Customer : CU-DAR001 Dart Helicopters Services Drawing Name : HELI UTILITY BASKET LH/RH 350/355
 Job Number : 34279
 Estimate Number : 10208
 P.O. Number : NIA Part Number : D350607043
 This Issue : 8/28/2007 S.O. No. : NIA Drawing Number : D350-607 REV F P7-9
 Prsht Rev. : NC Project Number : N/A
 First Issue : NIA Type : LARGE FAB ASSY Drawing Revision : F
 Previous Run : 33903 Material : NIA
 Due Date : 9/14/2007 Qty: 1 Um: Each
 Written By :
 Checked & Approved By : 070828
 Comment : Est Rev:E as Per DSI9318 06-01-24 JLM

DESIGN <i>CP</i>	DRAWN BY <i>CP</i>	DART AEROSPACE LTD HAWKESBURY, ONTARIO, CANADA	
CHECKED <i>[Signature]</i>	APPROVED <i>[Signature]</i>	DRAWING NO. DSI 9318	REV. A SHEET 1 OF 1
DATE 06.01.06		TITLE WASHER ADDITION	SCALE NTS
A	06.01.06	NEW ISSUE

DART SERVICE INSTRUCTION

TO AMEND INSTALLATION INSTRUCTIONS D350-607 REV. F

Figure 5- Basket Replacement Parts
(D350-607-043 Heli-Utility-Basket™)

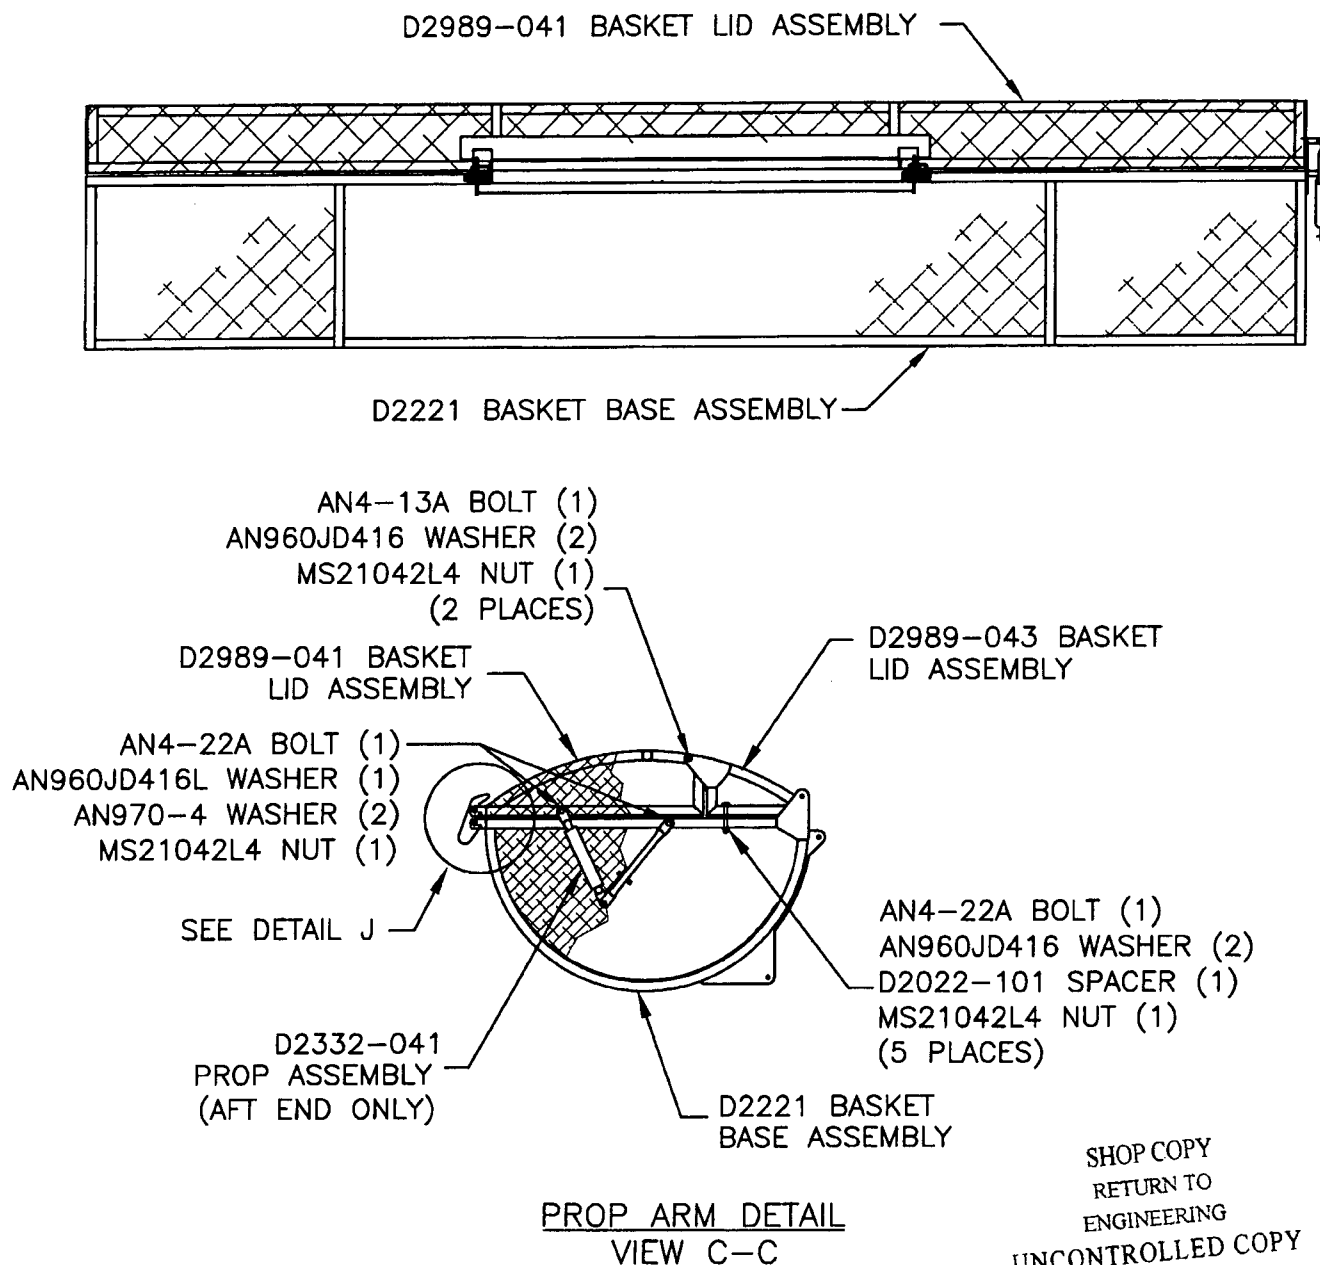
The corrected bolt stackup from Figure 5 of installation instructions D350-607 Rev. F is given below:

AN4-13A BOLT (1)
AN960JD416 WASHER (1)
HINGE PLATE (REF)
NAS1515H4 WASHER (1)
BASKET FRAME (REF)
AN960JD416 WASHER (1)
MS21042L4 NUT (1)
(2 PLACES)

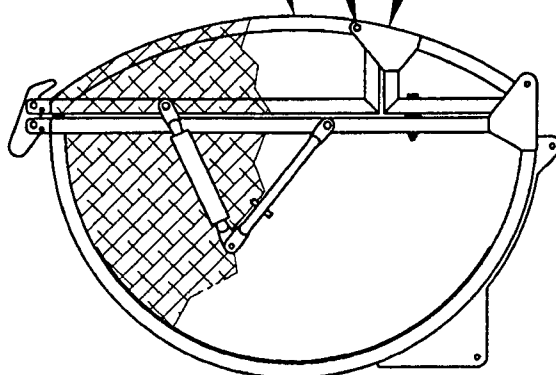
To reduce the possibility of damaging the finish, a **NAS1515H4** washer (2 places) has been added between the hinge plate and basket frame on the **D350-607-043/-047 Heli-Utility-Basket**.
